## Response to queries for licence BUML1472

The below provides information from the email from 01/04/2015

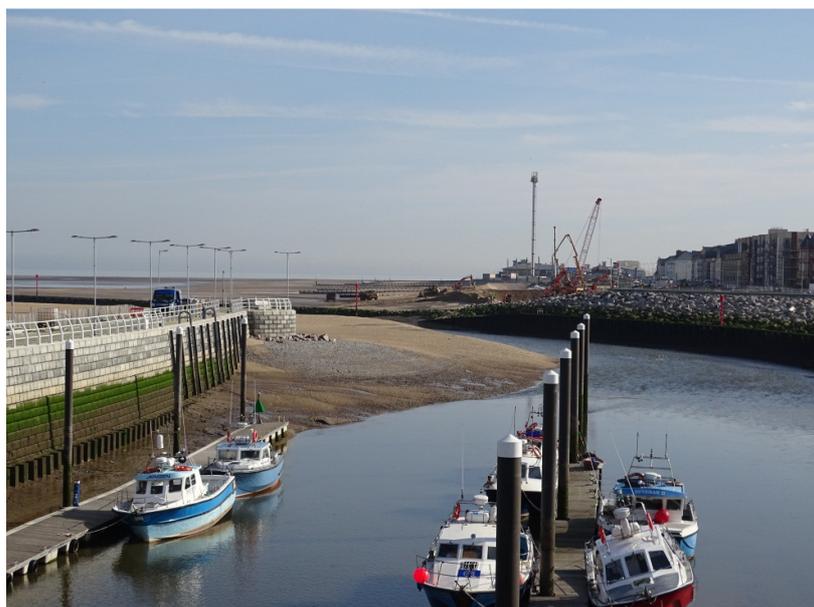
The various areas that require dredging under this variation are:

**Area 1** - Around the existing pontoons – this has an average volume of 1000m<sup>3</sup>. The reasoning for this removal is that sand is building up around the pontoons. The levels proposed for excavation are -0.5mAOD where required in order for the boats to rest level in the harbor at low tide (please see drawing H3/14409/D/05 attached).

**Area 2** – Area under the footbridge and central pontoon – this has an average volume of 3,081m<sup>3</sup>. This area requires a level of -1.5mAOD to allow access to the main navigation channel and pontoon areas.

**Area 3** – the turning circle – this has an average volume of sand to be removed of 6,000m<sup>3</sup>. This volume of material is required to be removed to allow access to the navigation channel and the fenders on the quay wall. Without this removal of sand the harbour is not fulfilling its requirements.

**Area 4** – the navigation channel – this has an average volume of 250m<sup>3</sup> to be removed. The removal of this sand is required for the navigation of the vessels using the harbour.
